# Western Harbour Tunnel and Warringah Freeway Upgrade

## Part B

Response to key stakeholder  
submissions

**Figure B14-3 Trend in annual mean NO<sub>2</sub> concentration (Source: Annexure D of Appendix H (Technical working paper: Air quality))**

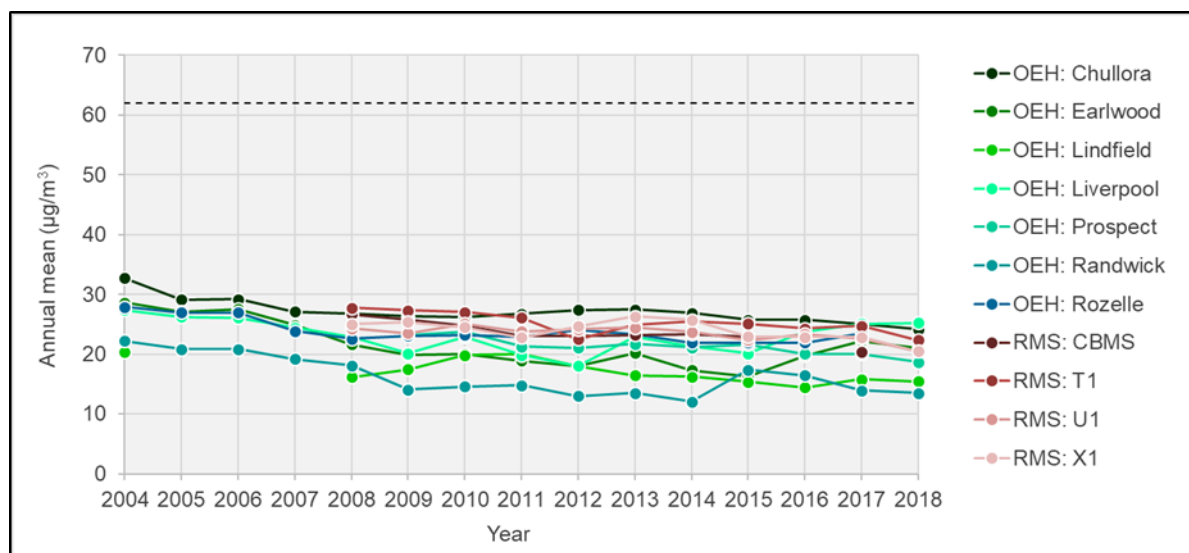
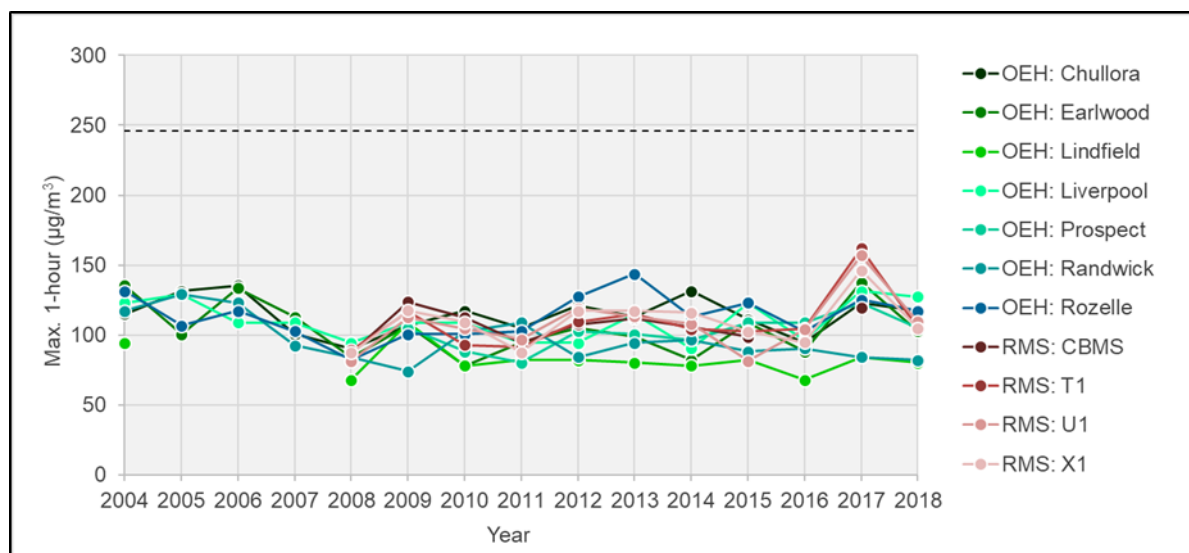
With regard to the NO<sub>2</sub> standards in the National Environment Protection (Ambient Air Quality) Measure, and used in the air quality assessment, these were based on the understanding of the health effects at the time it was introduced (1998). The 2011 AAQ NEPM review concluded there was sufficient evidence to support the review of the NO<sub>2</sub> standards (and others). The latest review published in 2019, recommends an initial move to annual average and 1-hour NO<sub>2</sub> standards 185 µg/m<sup>3</sup> and 39 µg/m<sup>3</sup>, and to 164 µg/m<sup>3</sup> and 31 µg/m<sup>3</sup> by 2025.

Figure B14-3 and Figure B14-4 are taken from Annexure D of Appendix H (Technical working paper: Air quality) and show the general downward trend in annual average NO<sub>2</sub> in Sydney, to levels below the proposed 2025 standard of 31 µg/m<sup>3</sup>. Maximum 1-hour measurements remain steady but are generally below the proposed 2025 standard of 164 µg/m<sup>3</sup>. Given the small contributions that the ventilation outlets make to the total ambient air quality at ground level, the project is unlikely to change these trends.
